Re:	Initial Submission Review	Blue Eagle Logistics Park - Master Plan
	Application Number:	DA-2375-00
	Case Numbers:	2024-7001-00

PLANNING DEPARTMENT COMMENTS

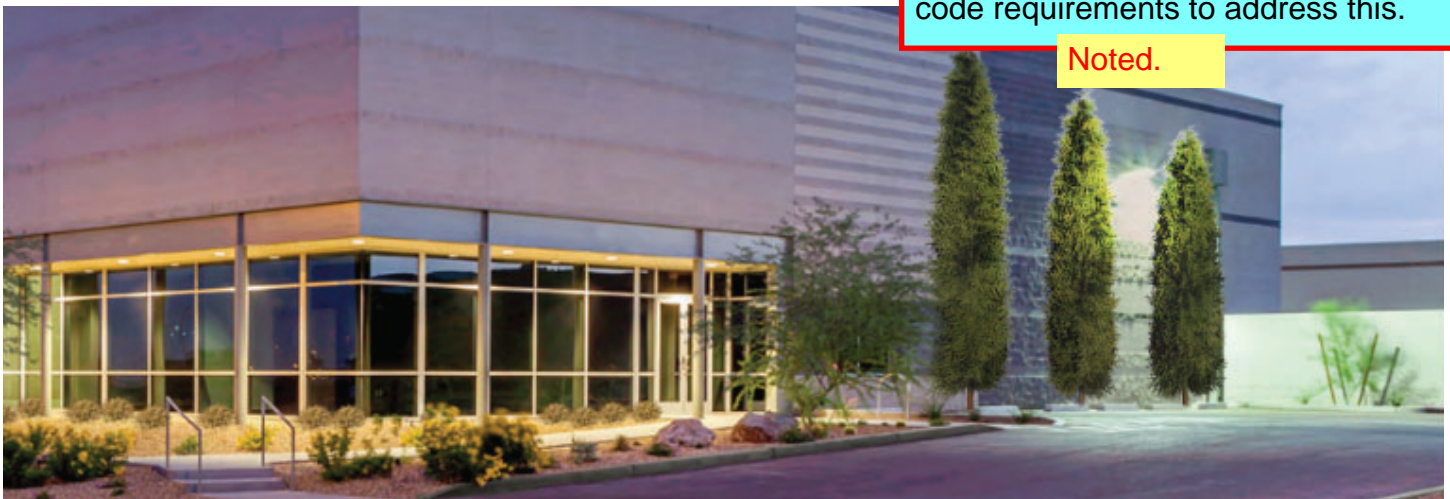
If drive through restaurants are anticipated, please note the drive through itself is not permitted between the street and facade of the building. If that is anticipated, then an adjustment would be necessary and the landscape standards for the Master Plan should include screening above and beyond code requirements to address this.

Noted.

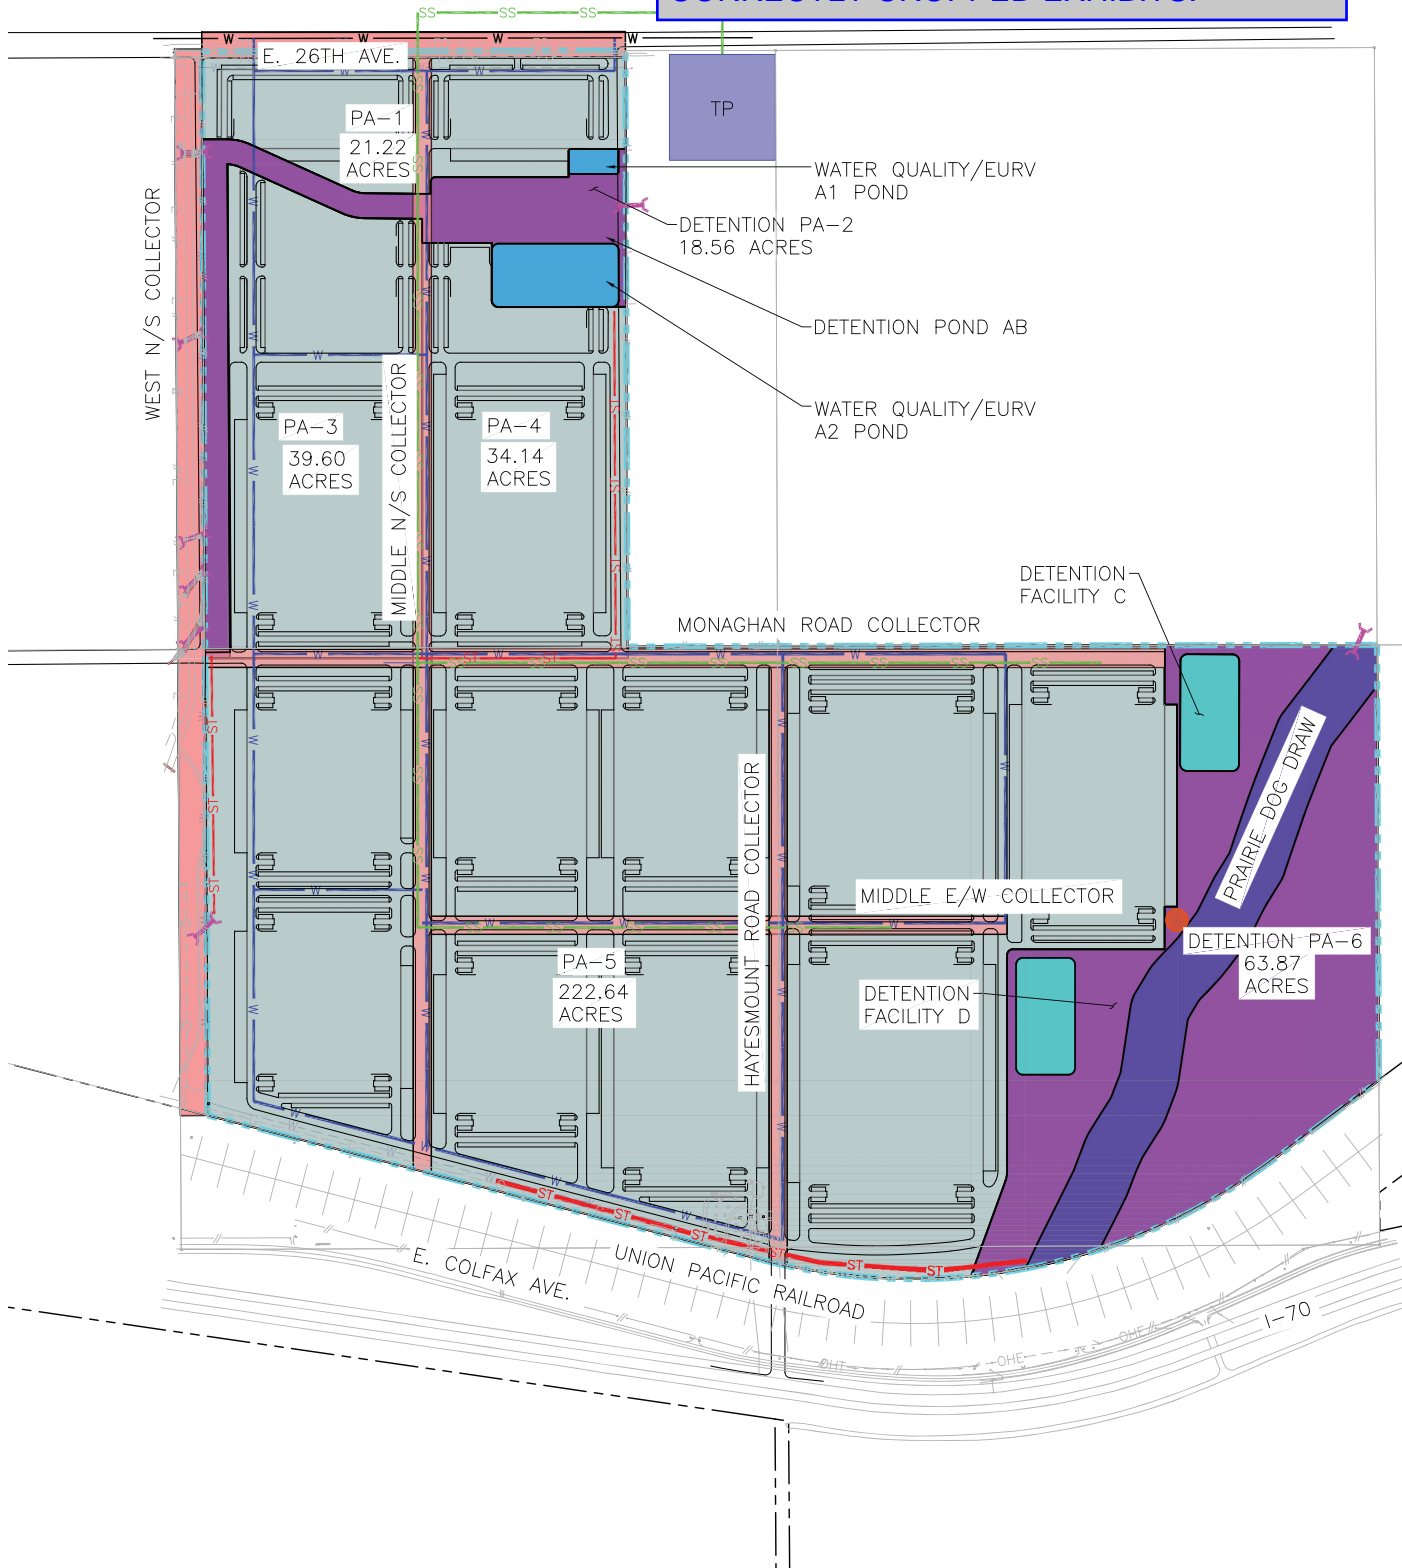
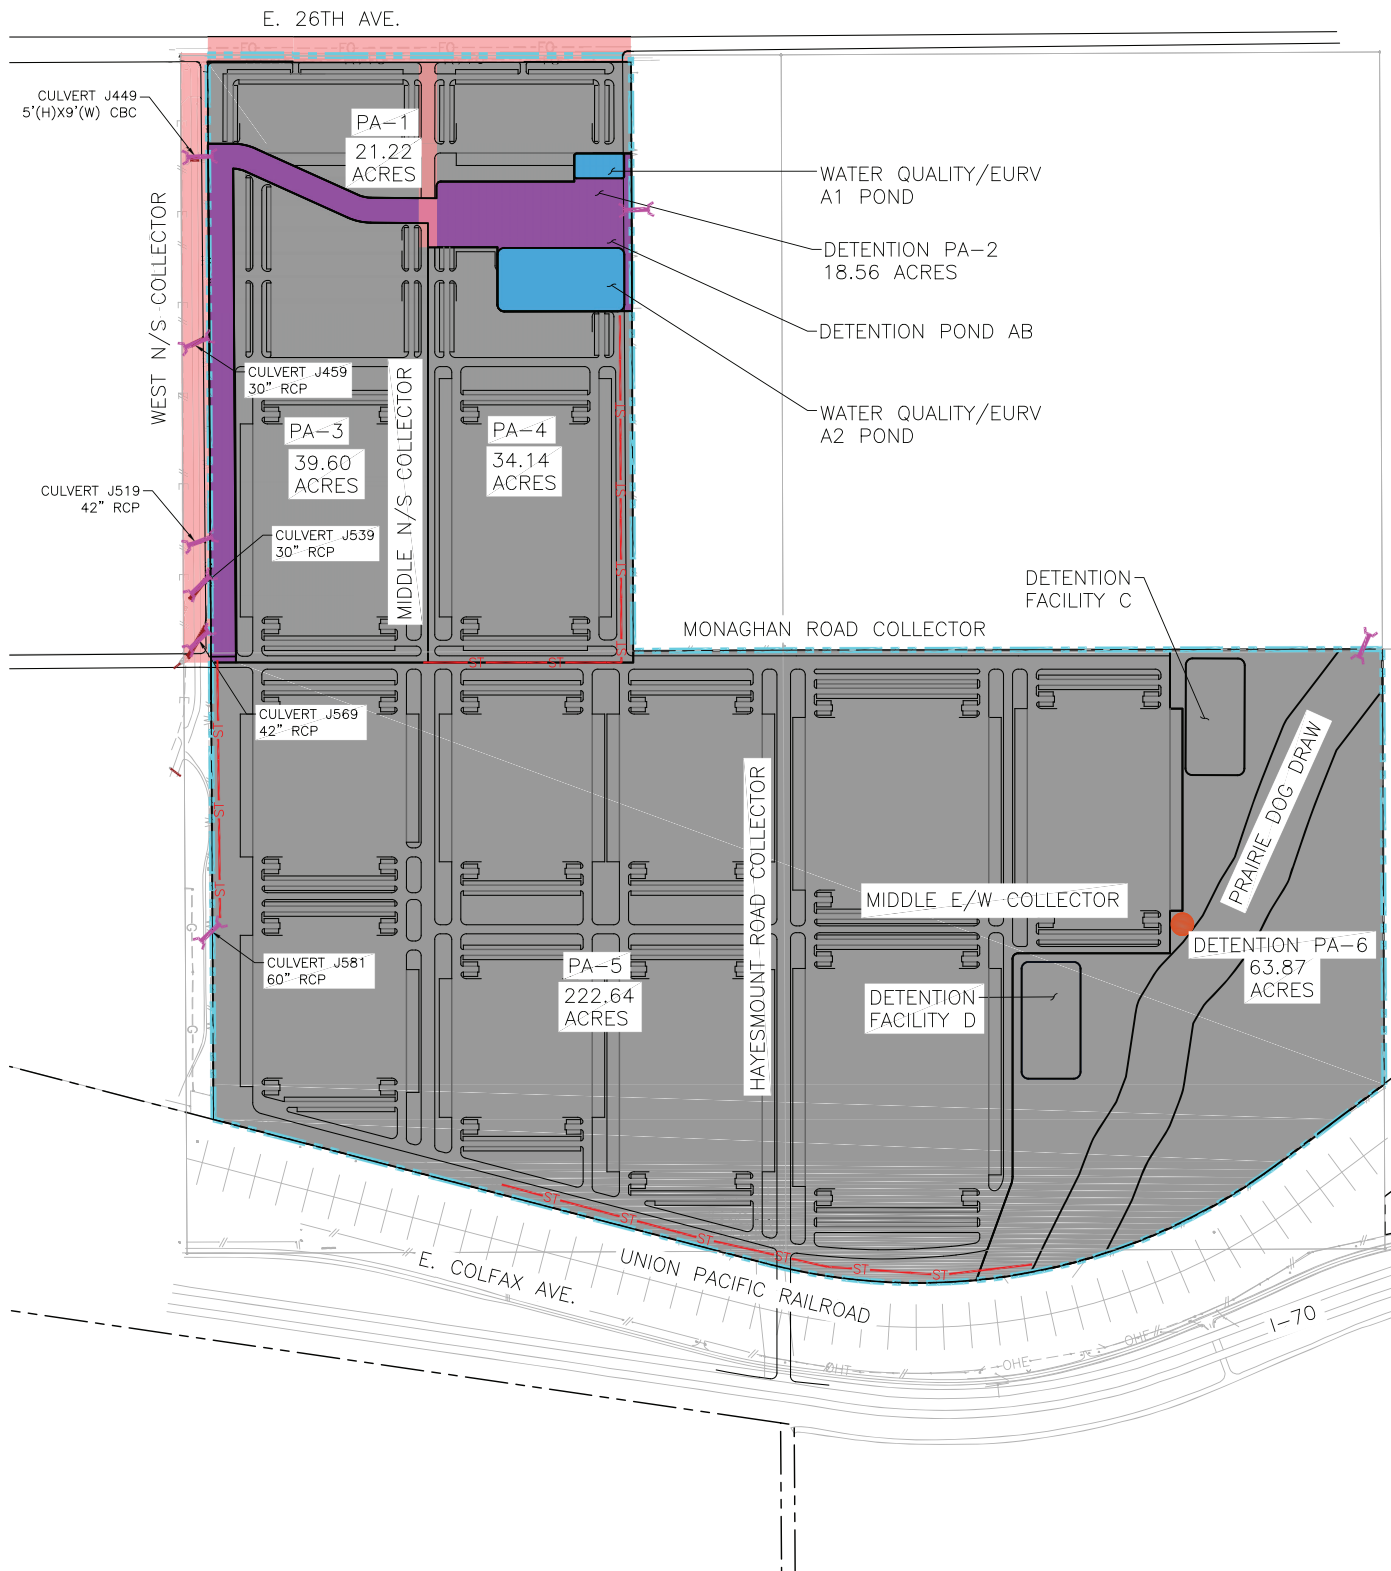
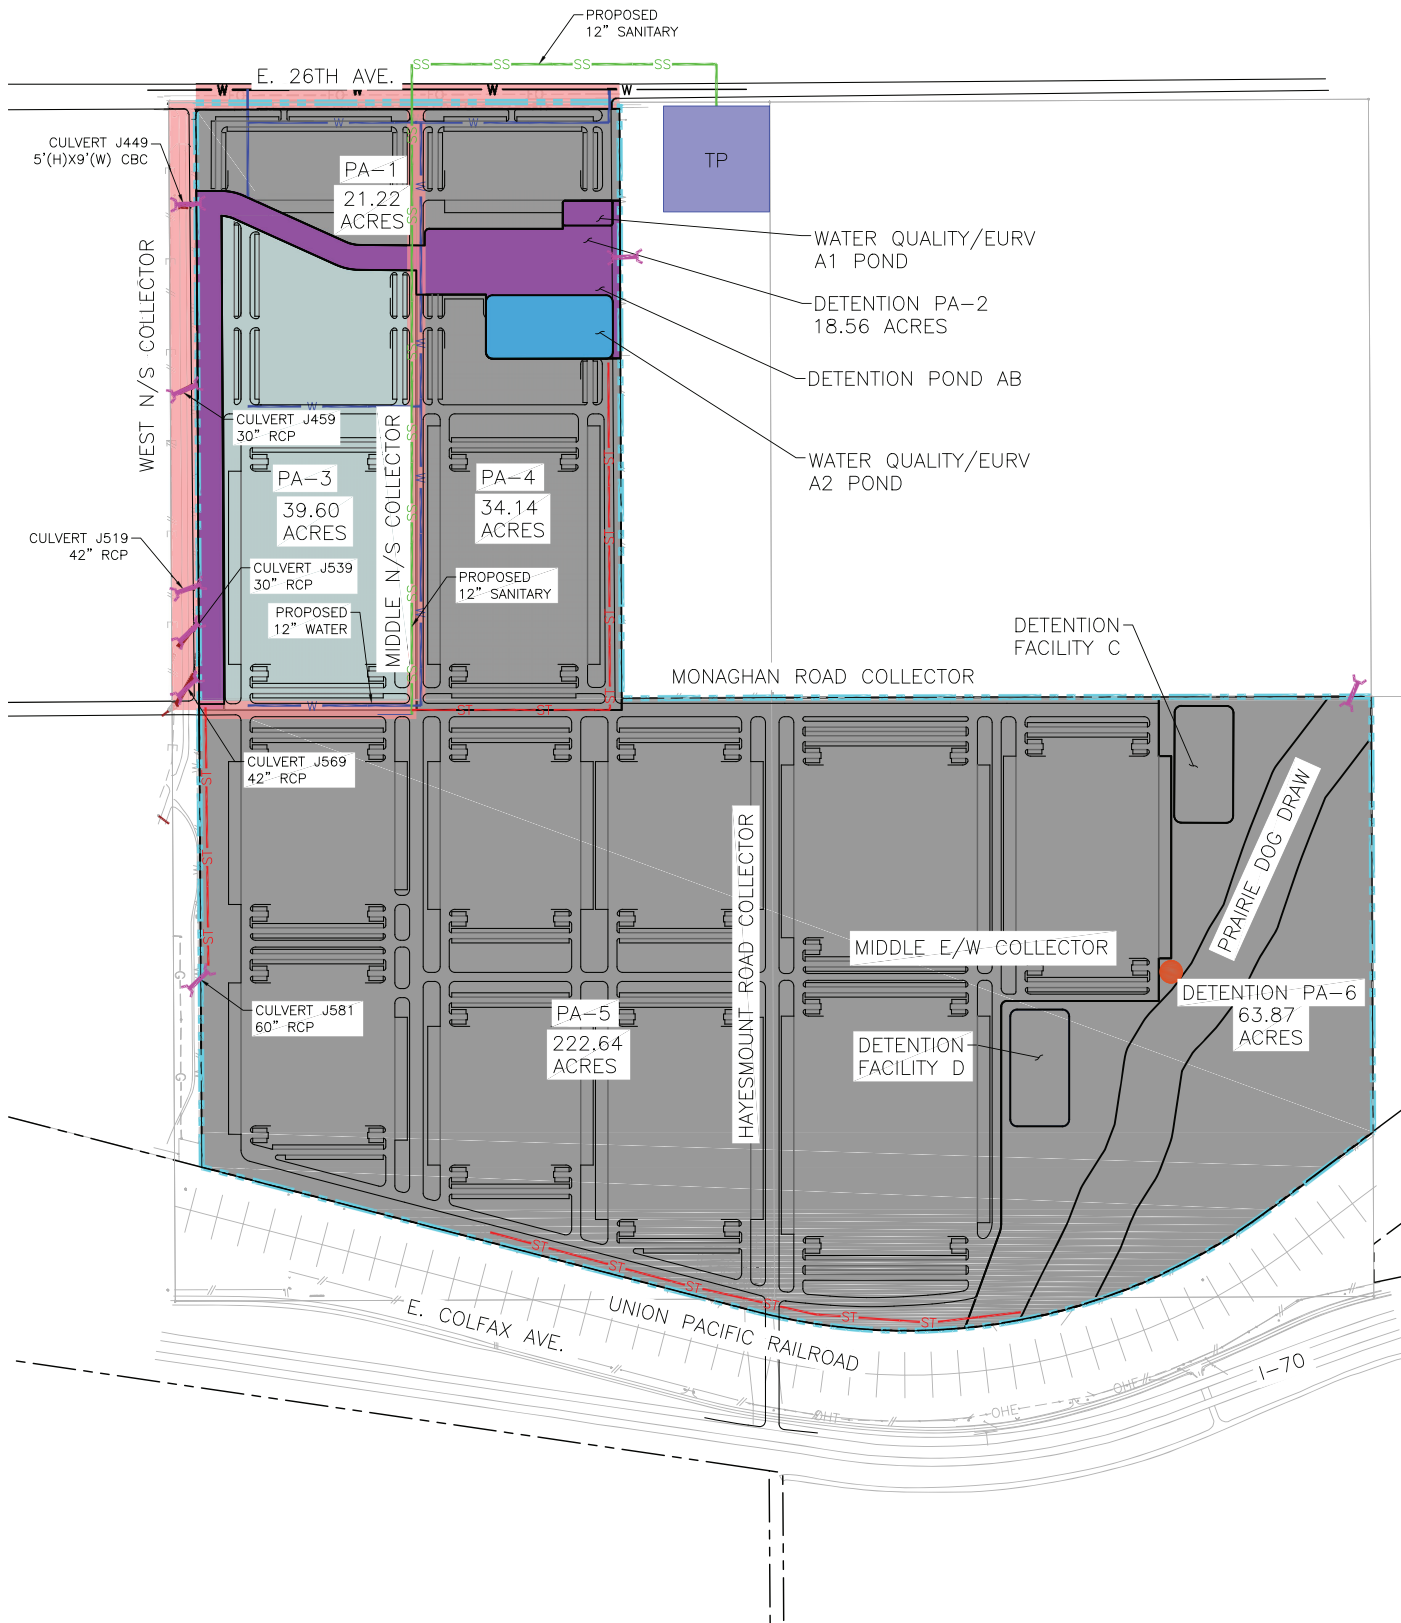
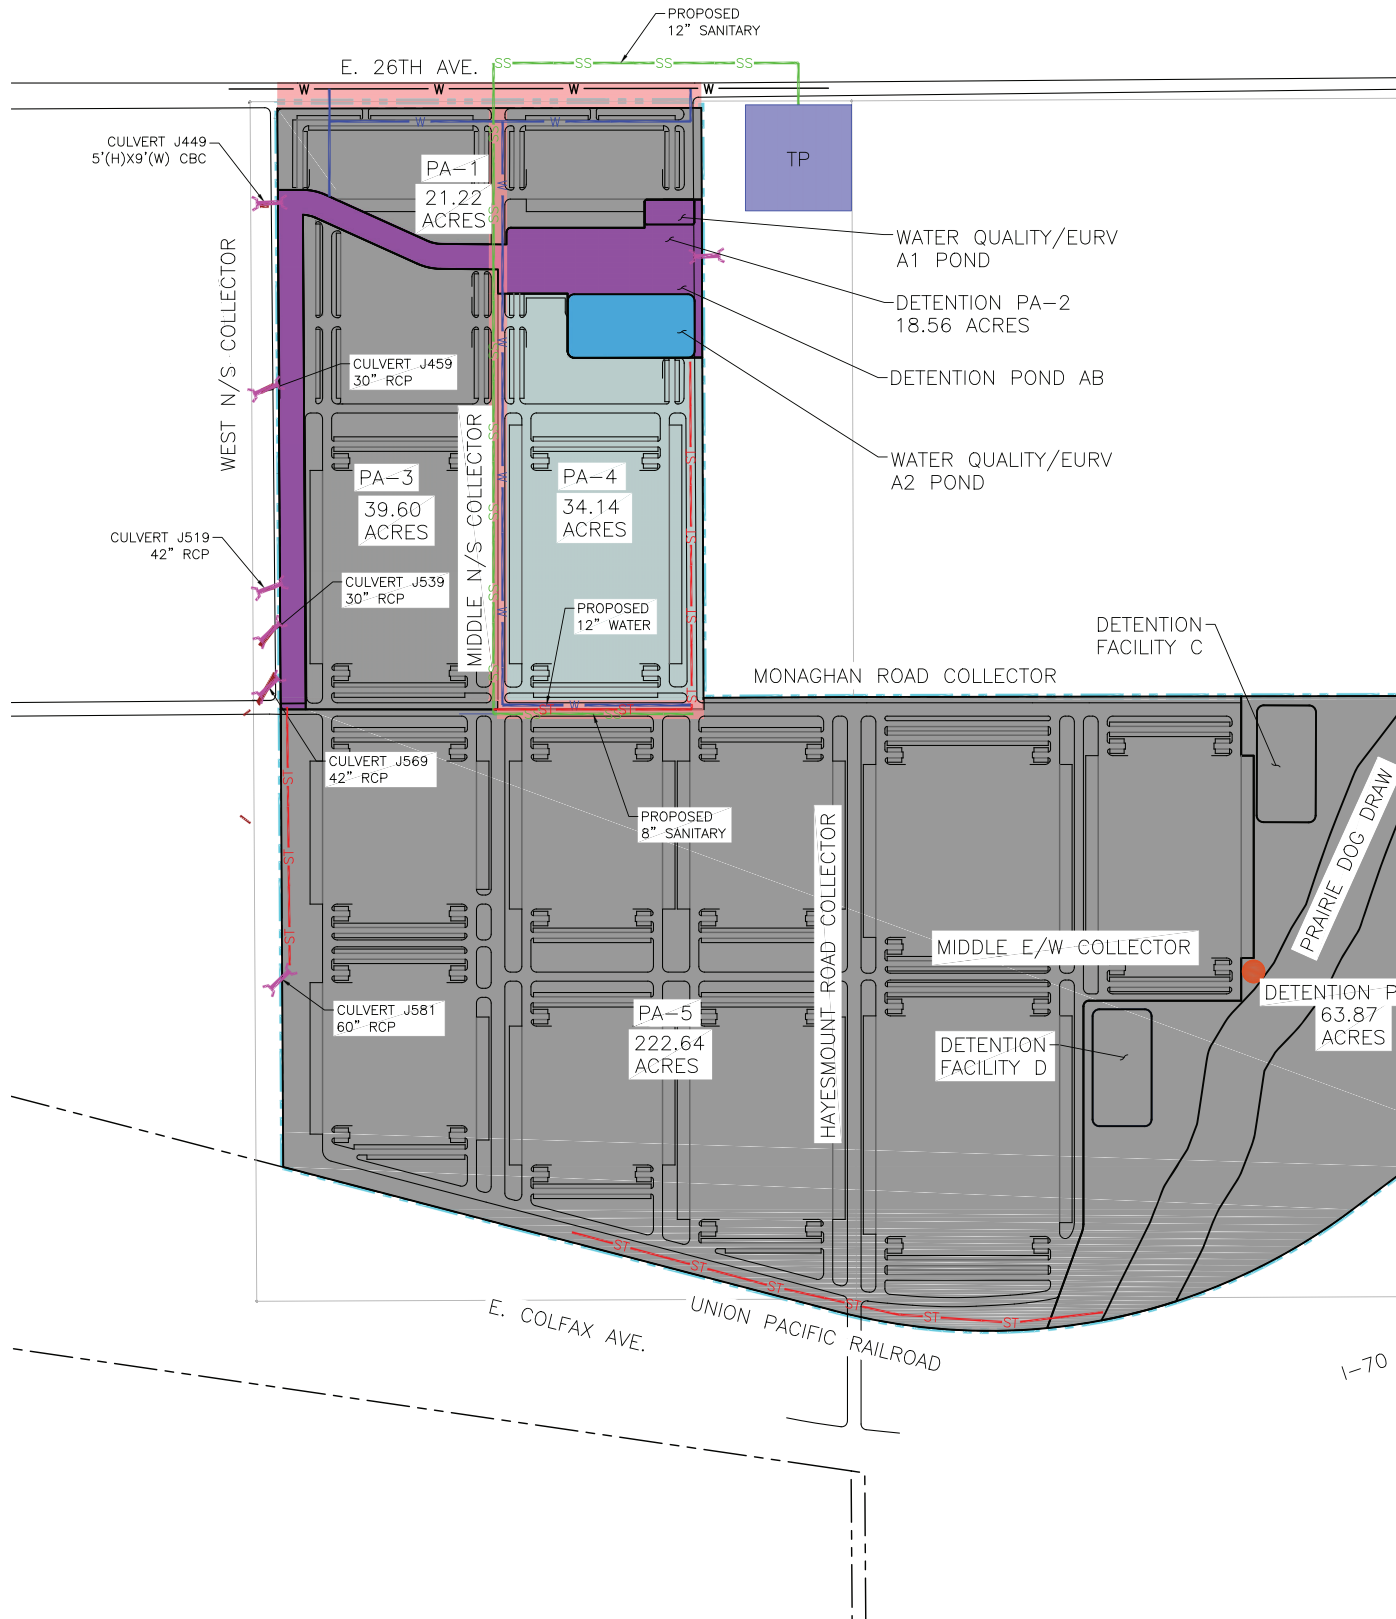
Please add Legends and Titles

Where are the legends for these graphics? Where are the titles? What are each of these supposed to be representing?

EXHIBIT ORIGINALLY INCLUDED LEGENDS AND TITLES, BUT WAS CROPPED INCORRECTLY. REPORT NOW INCLUDES CORRECTLY CROPPED EXHIBITS.
